Planning Commission
Council Chambers
September 20, 2022 – 6:00 p.m.
233 South Main Street, Monroe, Ohio

TO: Members of the Monroe Planning Commission
FROM: Kameryn Jones
Assistant Development Director

DATE: September 20, 2022
RE: Information Packet for September 20, 2022 Planning Commission Meeting at 6:00 p.m.

I. Case No. 2022-9-9— Consideration of Site Plan Application for an Office Warehouse Facility on Baker Drive.

Proposed Retail Center For:
BUTLER DISPENSARY
Monroe, Ohio

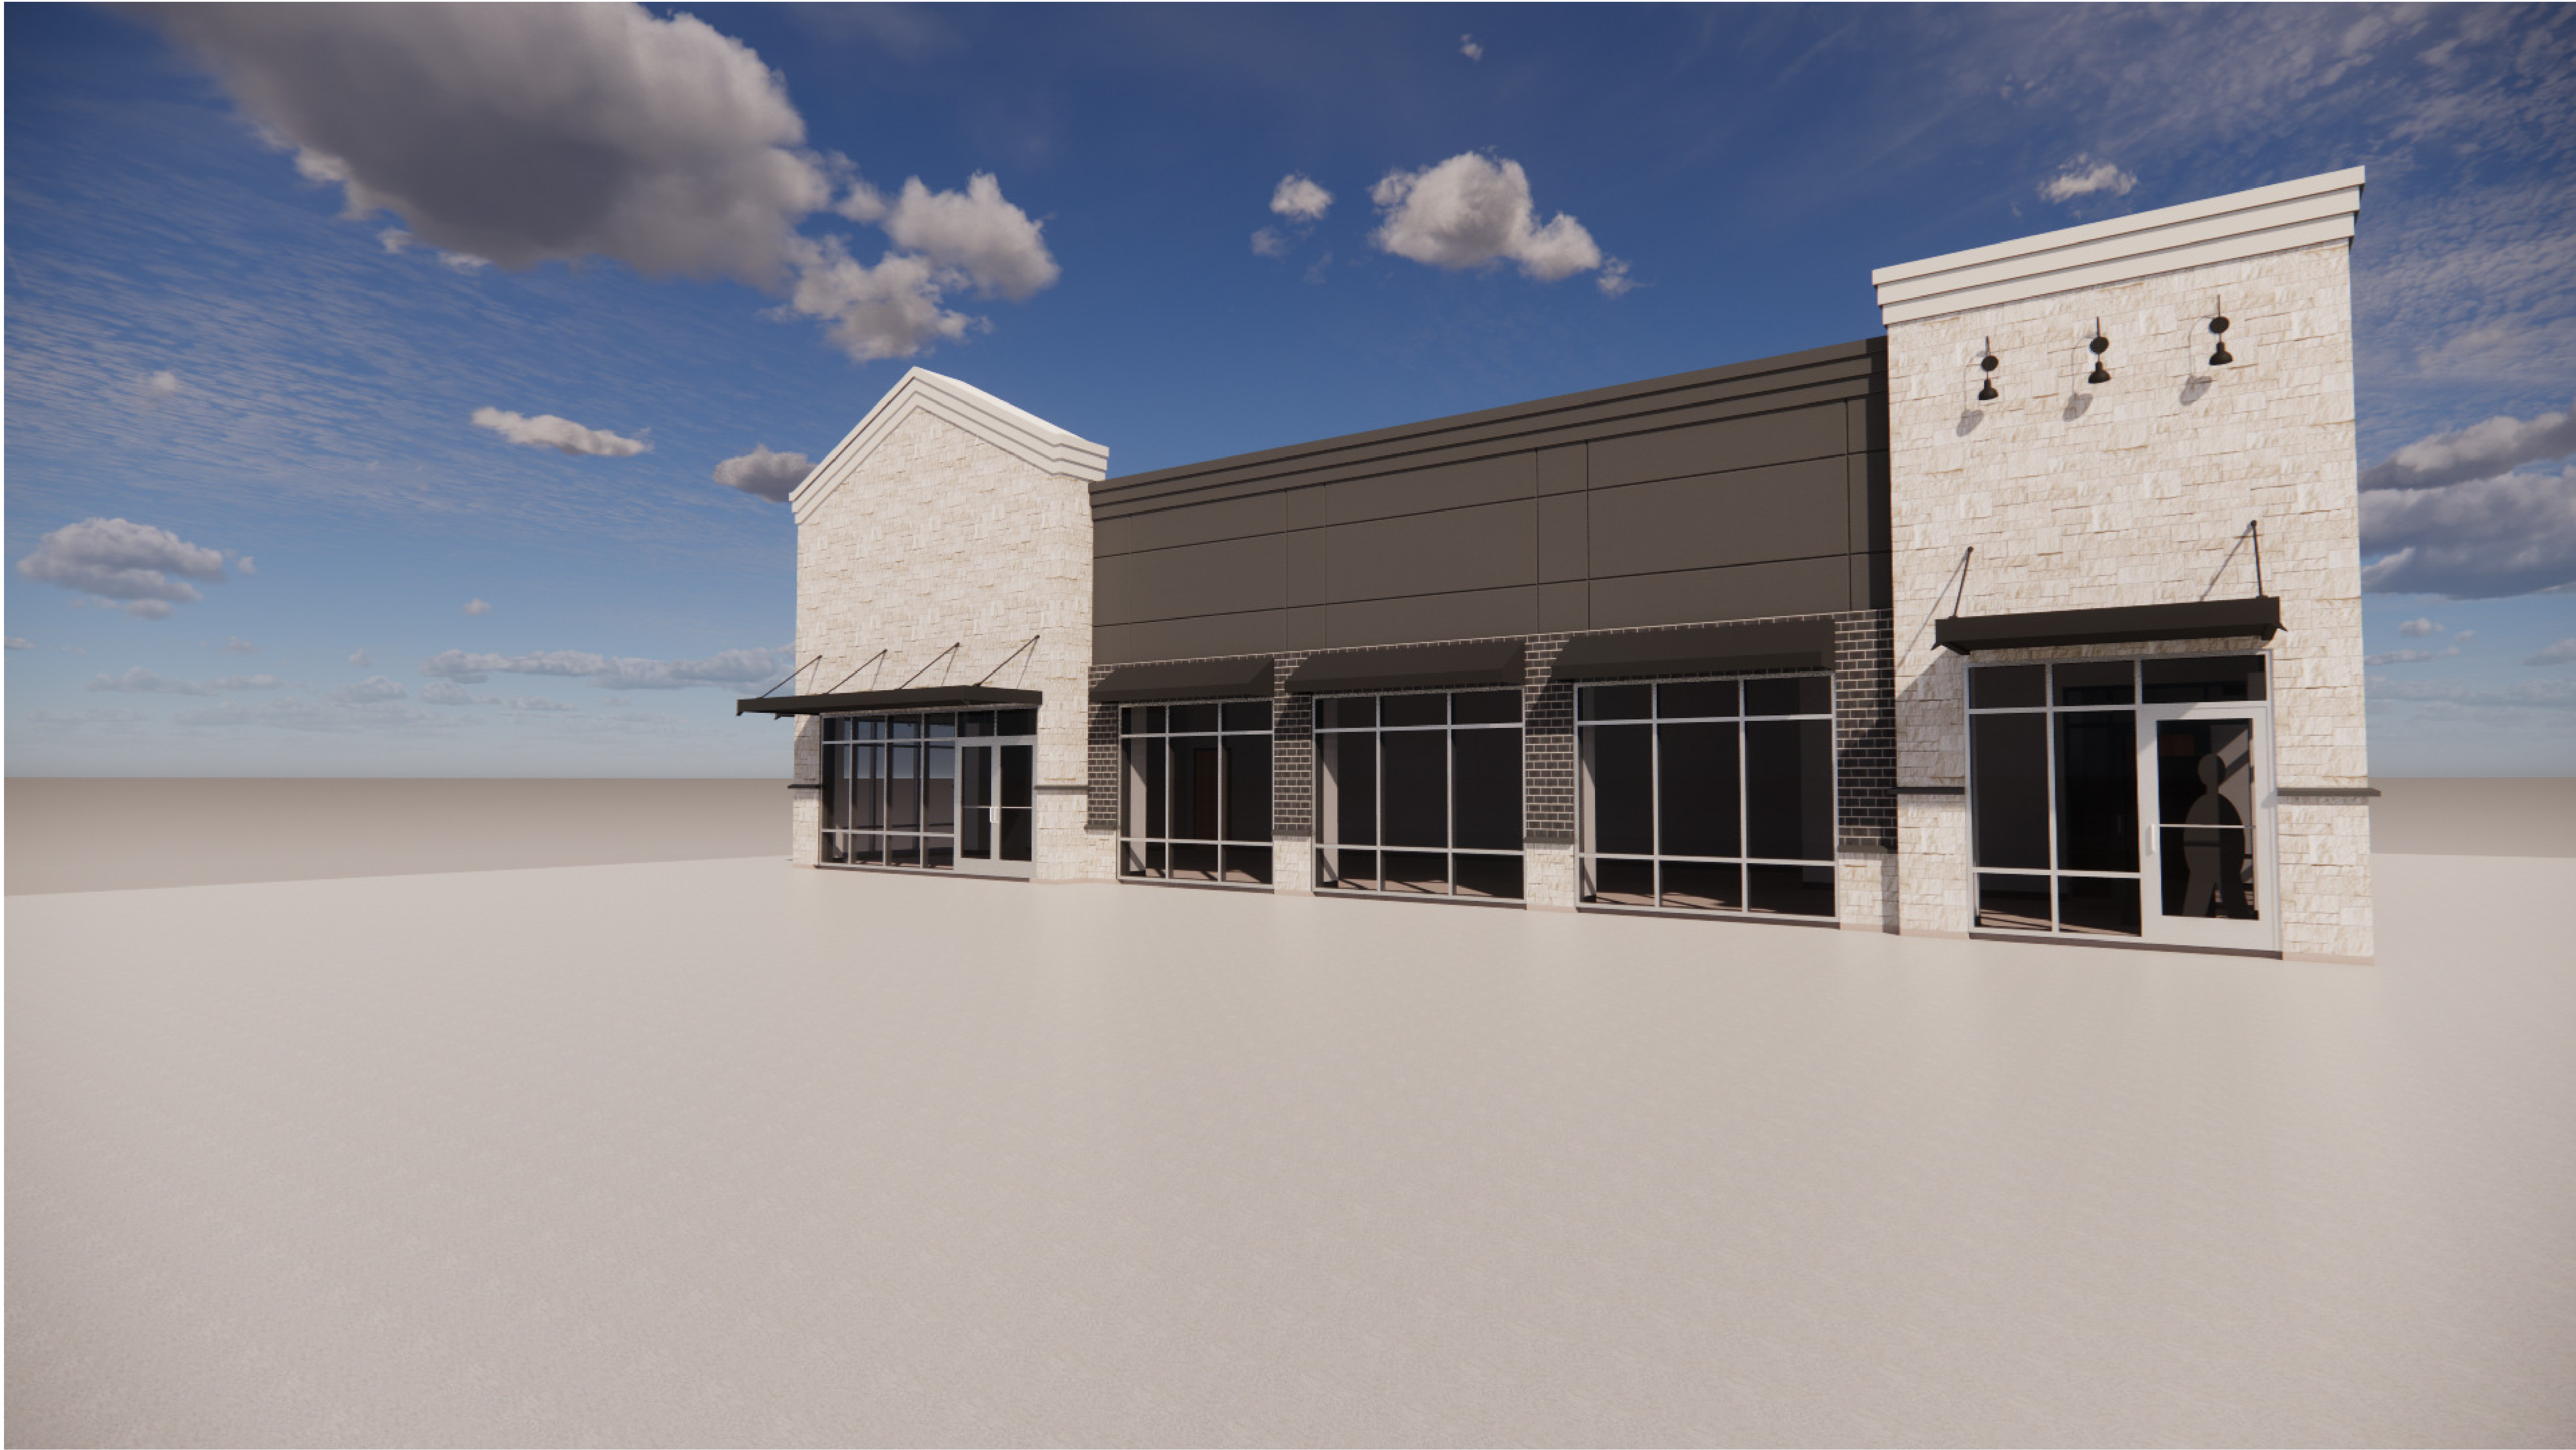
- At the July 19th meeting, Planning Commission approved Case No. 2022-7-8, a site plan for a medical marijuana dispensary located on Clarence F Warner Drive.
- After Planning Commission approval, the applicant approached staff regarding the approved site plan submittal, specifically regarding the architectural elevations presented to the board at the meeting. The applicant proposed a change to the elevations, primarily to the materials and color of materials.
- Code Section 1203.06(l) Amendments of an Approved Site Plan provides the Code Enforcement Officer with the ability to approve minor changes to an approved site plan or to refer the request to Planning Commission for their consideration.

- Staff does not oppose the proposed change in elevations as they still meet minimum code requirements in regards to material type.
- Percentages of base-body-cap, windows, and required building offsets are still met.

- Staff recommends approval of the amendment to approved site plan 2022-7-8.
